**TOWN OF HERNDON, VIRGINIA
ARCHITECTURAL REVIEW BOARD WORK SESSION AGENDA
AUGUST 3, 2022
HERNDON MUNICIPAL CENTER
LARGE CONFERENCE ROOM, 2nd Floor
777 LYNN STREET
7:30 P.M.**

Title: ARB #22-018; New signage and awning alteration; 1142 Elden Street, 1100 Herndon Parkway

Subject: Pre-application ARB Discussion Item, DPA #21-01, 555 Herndon Parkway

Subject: Pre-application ARB Discussion Item, DP #21-01, 555 Herndon Parkway

HERNDON IDENTITY/
PLACE MAKING

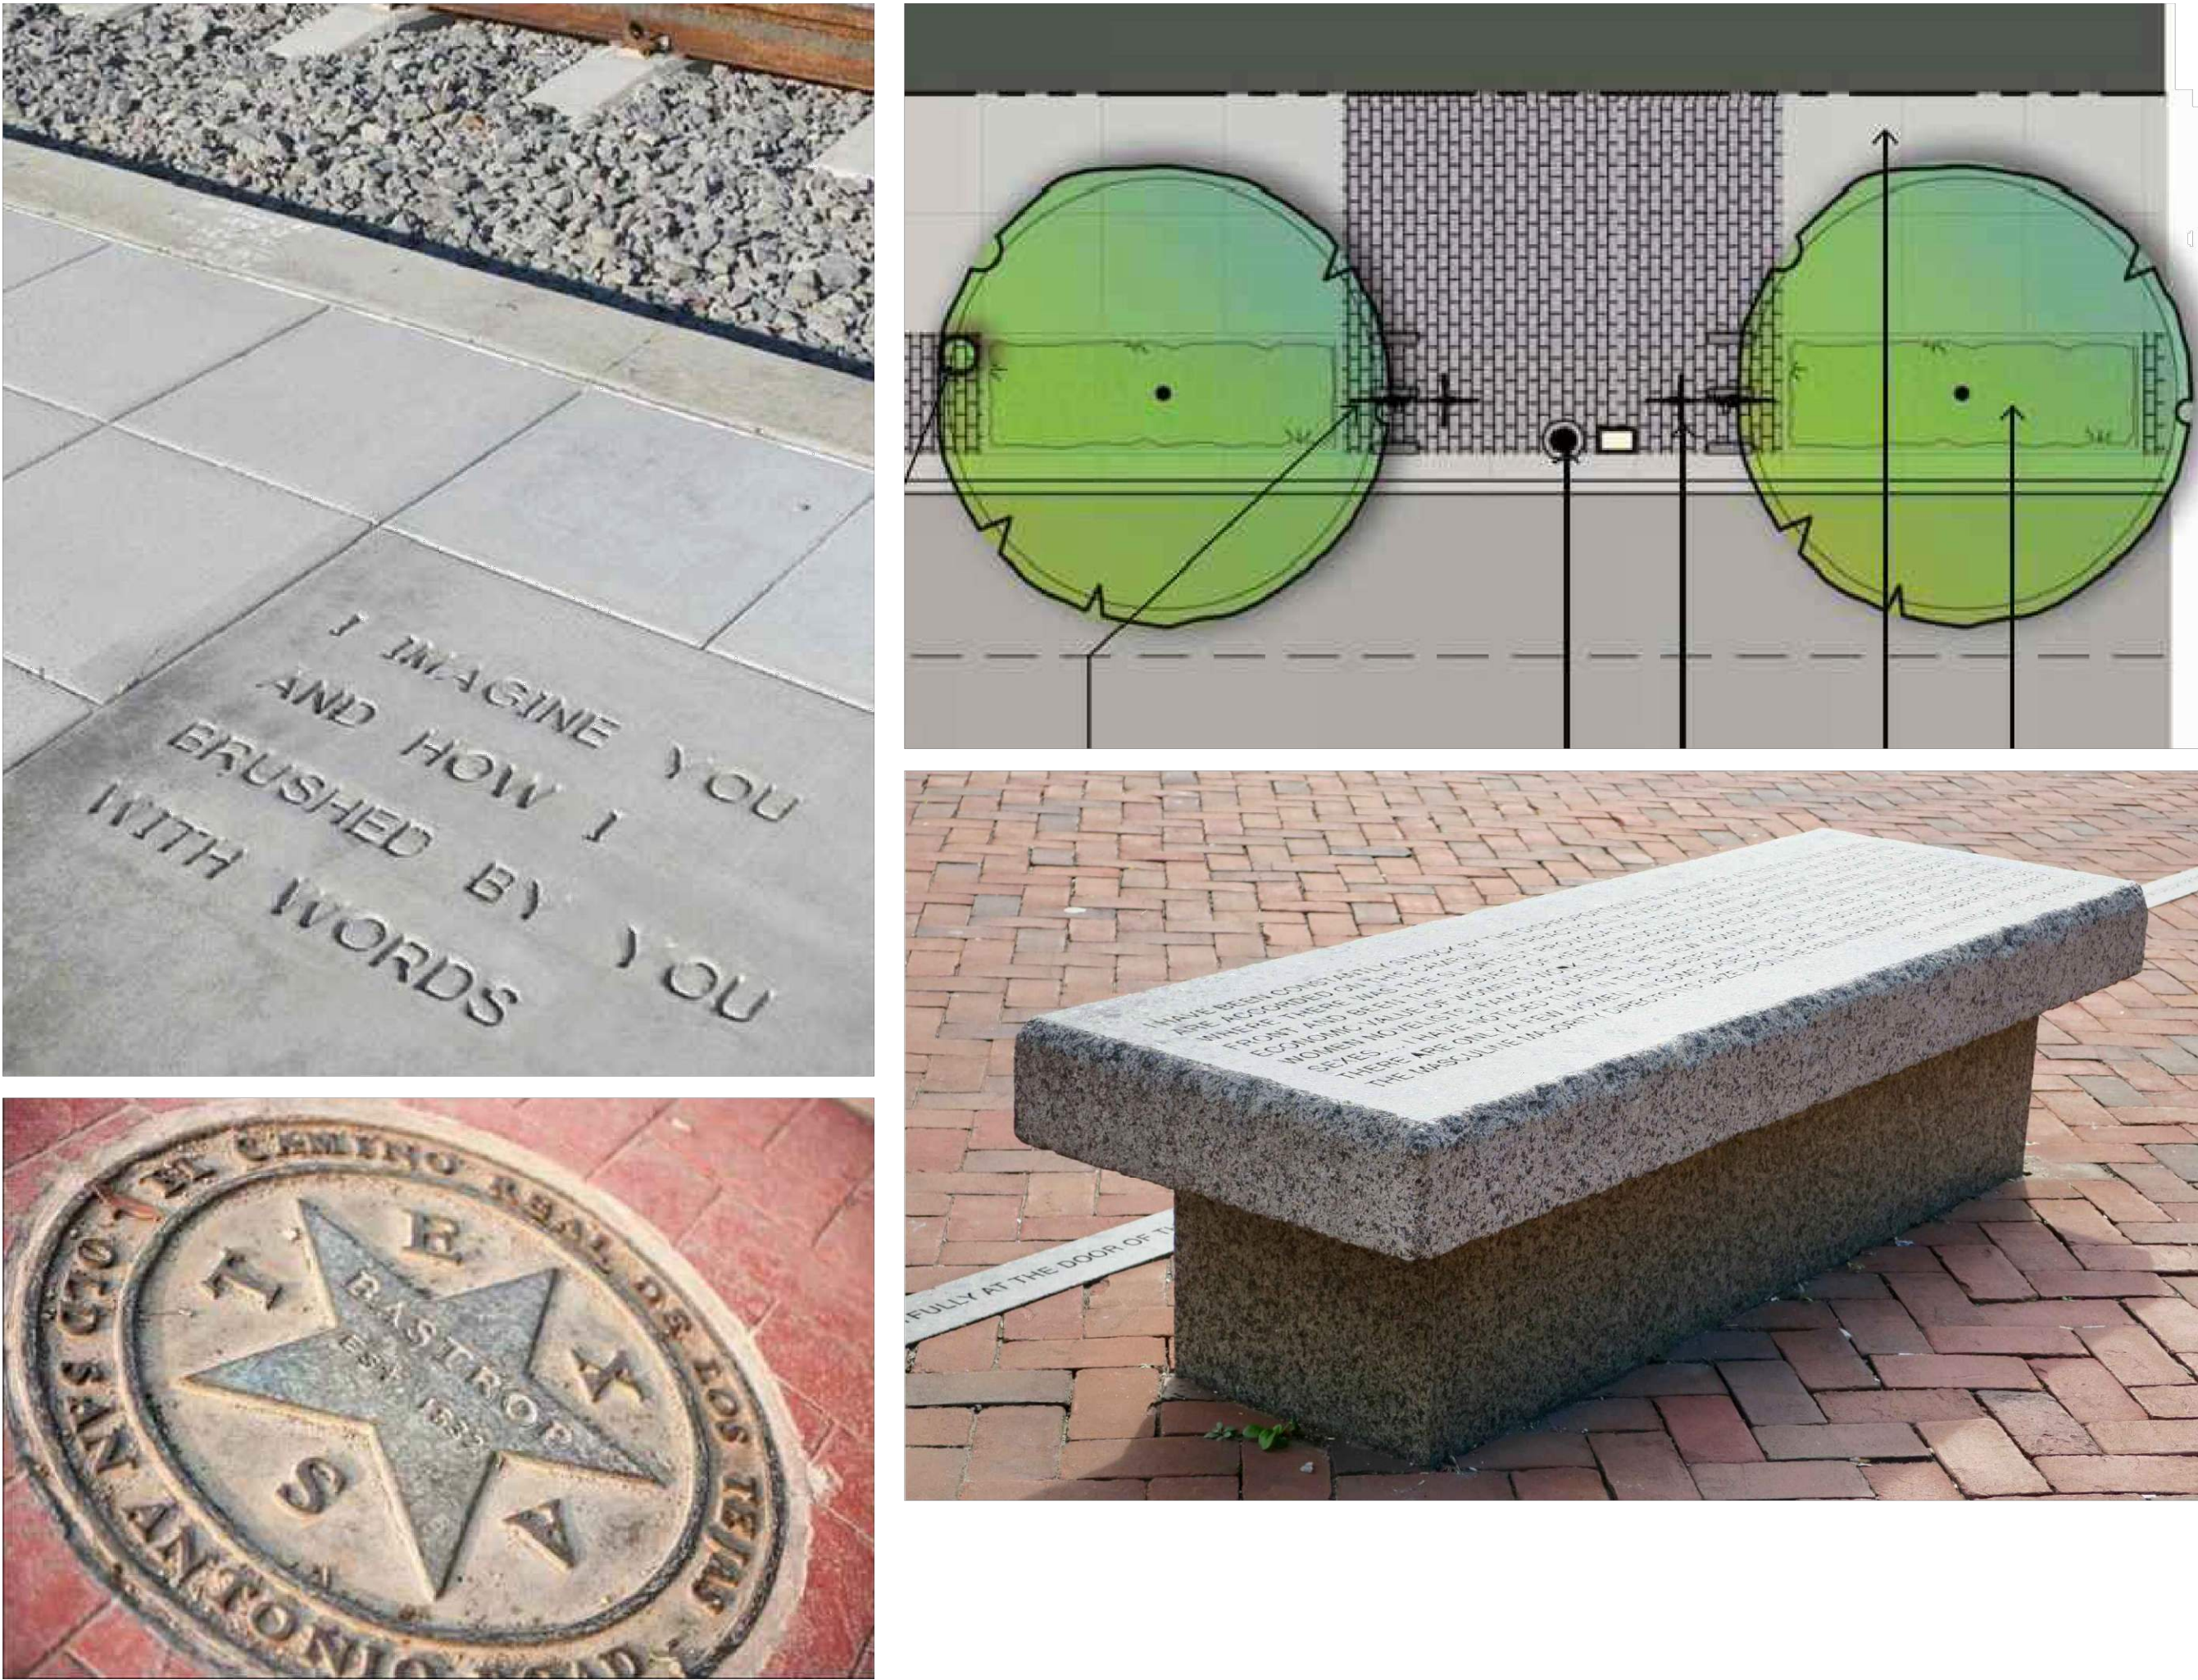
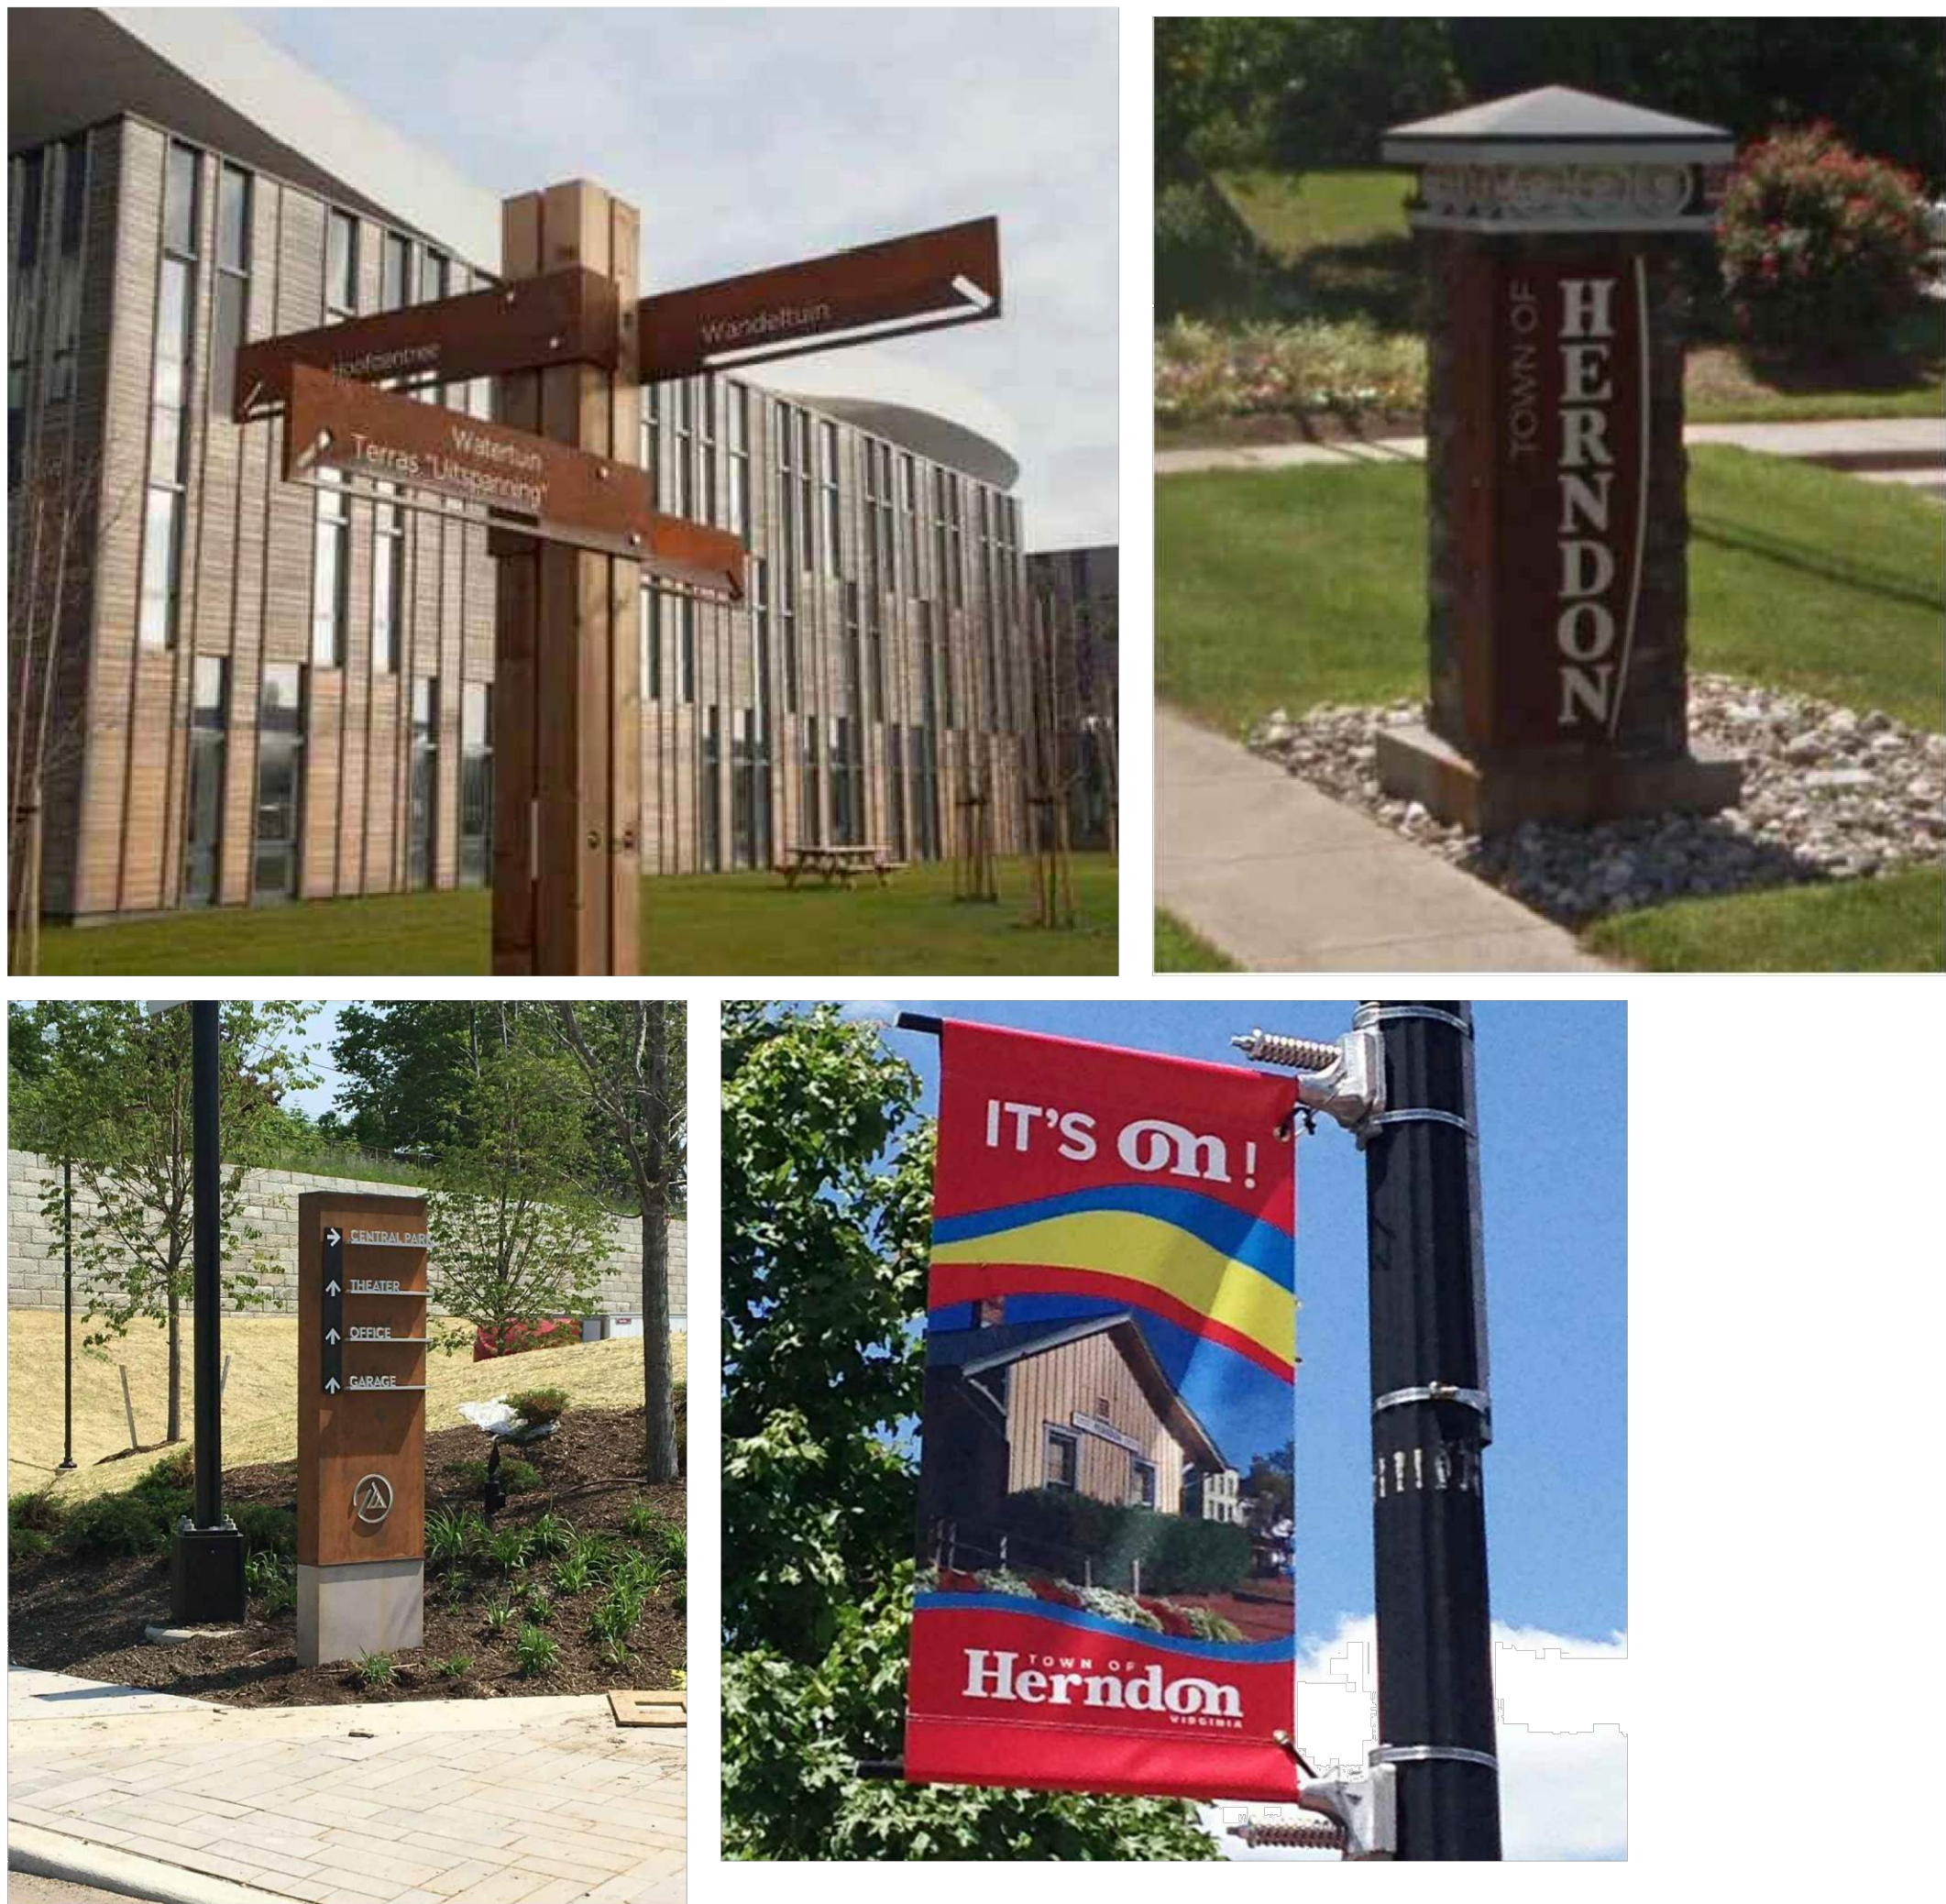
Sheets 19.0 through 23.0 of the applicant's submittal provide images of history and heritage ideas, outdoor furnishing, pavement details, recreational amenities, and green infrastructure. It should be noted that these are only conceptual in nature. The staff believes that while some of these images are appropriate for development in the HTOC, others are less so.
